Subject: Nyton Nursery Application AL/102/17/RES

Project **Land at Nyton Nurseries
Westergate**

Title **Play Strategy
Southern LEAP**

Extract from Tree Survey
Reference JSL2869_770

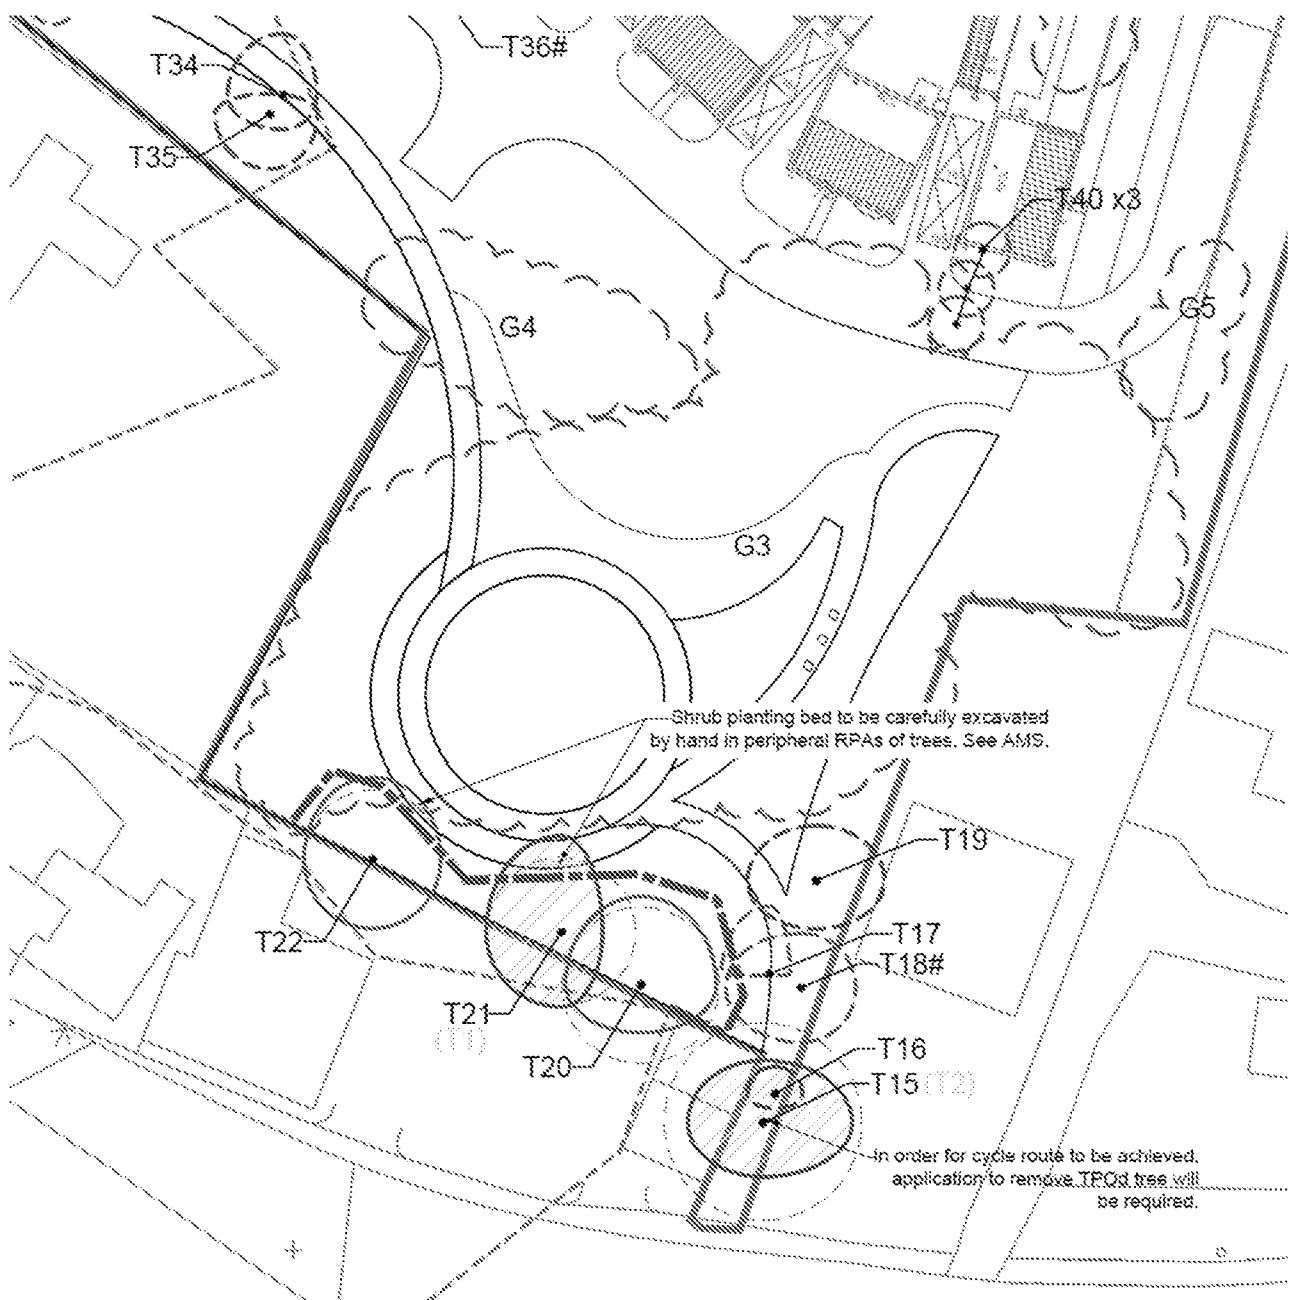
Another matter which is also of great concern to us is the proposal to remove some trees that are protected by Tree Preservation Orders. These trees are significant features in the village and the Holm Oak in particular is very special. Westergate used to have many of these trees and this is one of the last ones remaining. The Oak and Ash trees (T15, T17, T18 and T19) are acknowledged by the Arboricultural Consultant in the Tree Survey as being fine specimens with many years life in them. The only reason that the developer is planning to remove them is to put in the cycle route, which we strongly object to in this location and feel that it could be adequately provided along the access further to the west. A footpath could easily be accommodated whilst retaining these beautiful trees. There are other fine trees such as willows, hawthorns, elders etc that are also being proposed to be removed and whilst they are not as attractive visually do still provide valuable habitat to wildlife. On summer evenings we see bats flying around our garden, which we are sure will now be lost. We understood that the Tree Preservation Order covered more than just tree T15 and we hope that any application to remove these trees will be rejected.

Extract from Play Strategy Southern LEAP
Reference JSL2869_102A

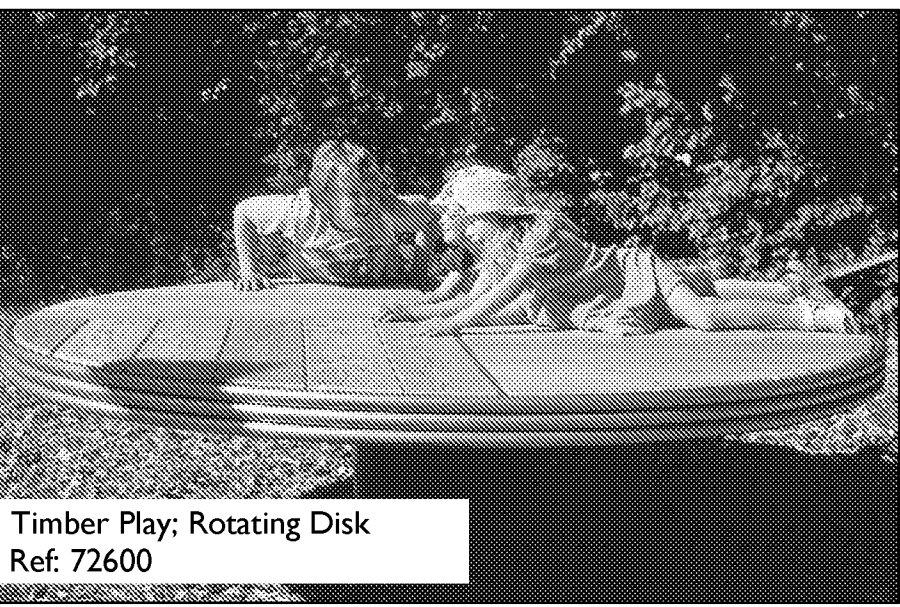
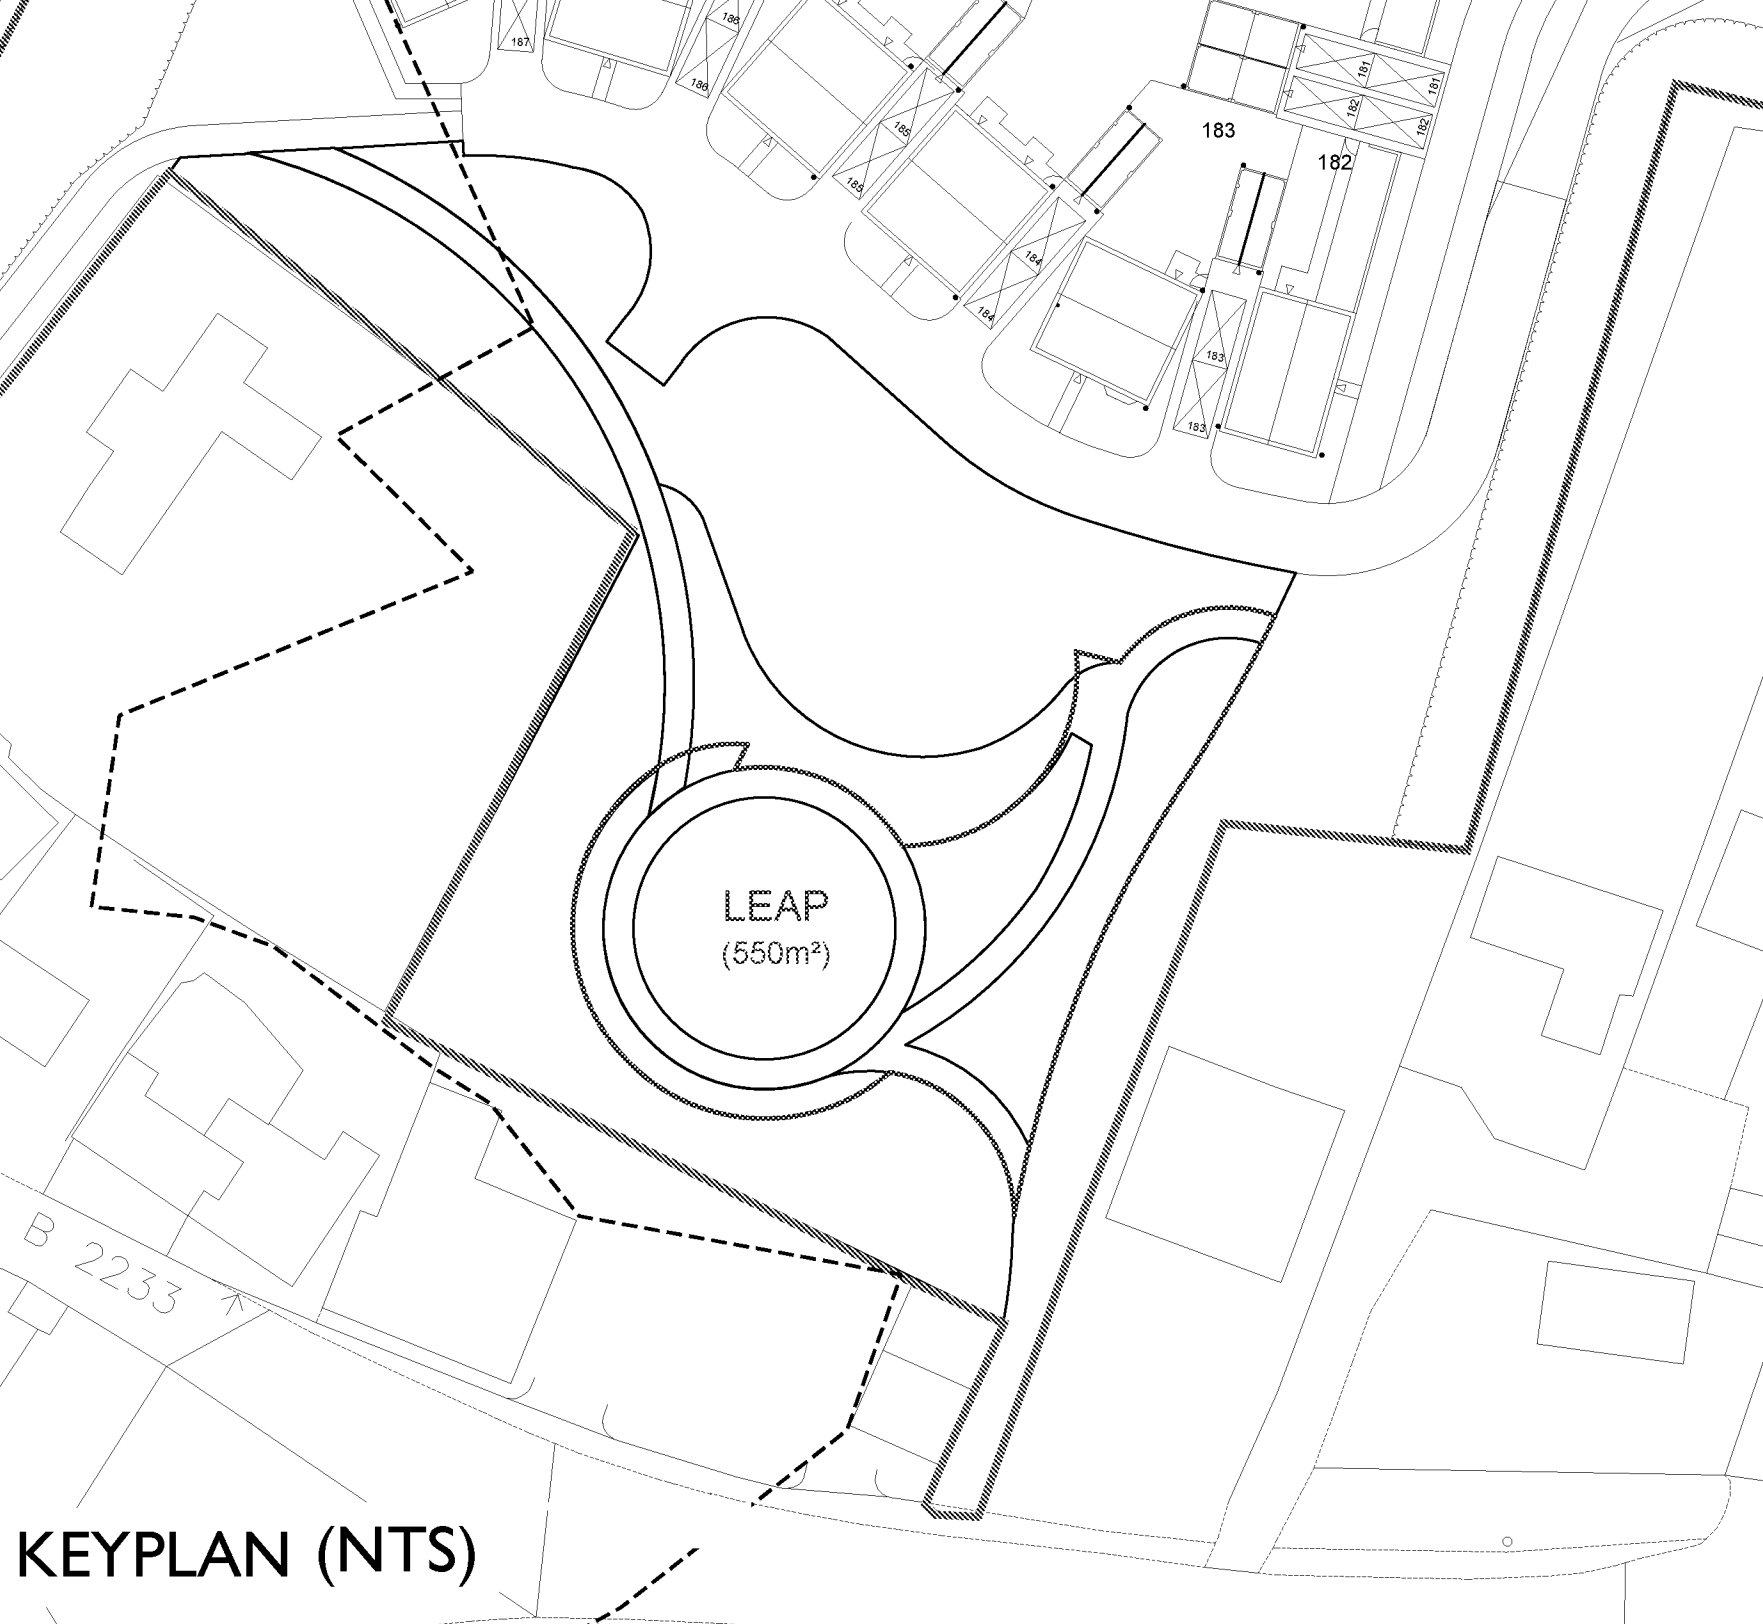
Further to our telephone conversation we are very concerned regarding the detailed landscaping proposals that have now been submitted. As you can see from the attached drawings, our property Jacaranda is adjacent to the site and the house is situated very close to the boundary. Our living room is on the first floor overlooking the site as is one of our bedrooms and our kitchen and dining room are on the ground floor. All these rooms have windows facing on to what is proposed to be a children's play area and cycle path. The cycle path is proposed to run immediately on the other side of our fence which will be within 2m of our house.

From looking at the landscaping plans for the whole development it would appear that all other existing houses bordering onto the proposed site are well screened with new or existing planting. Our property however, is going to be completely exposed with nearly all the very mature trees and shrubs being removed. We currently enjoy facing on to a natural wooded landscape and are well screened from the A29. If these plans are approved, then our quality of life will be significantly reduced. We will have to suffer the noise of the play area, cyclists and pedestrians walking close to our house and being able to see into our rooms and we will be greatly exposed to the noise and traffic pollution from the A29. These kinds of play areas like the one in Lime Avenue often attract teenagers after dark and we are concerned that as the proposed layout has no passive surveillance (except from us) it will encourage anti-social behaviour.

We appreciate that these play areas have to be provided and that the footpaths are needed, however we do not feel that enough consideration has been given to how our quality of life will suffer. We have tried on many occasions to meet the developer, but they will not meet us to discuss our concerns. I have attached to this email a sketch that I have prepared that demonstrates how the play area and cycle way could be provided whilst at the same time retaining many of the existing trees so that there can be a landscaped buffer that will give us a bit of protection. We would also like some reassurances that lighting will be prohibited along our western boundary as these lights will shine either into our bedroom and living room if they are tall or into our kitchen and dining room if they are low level.
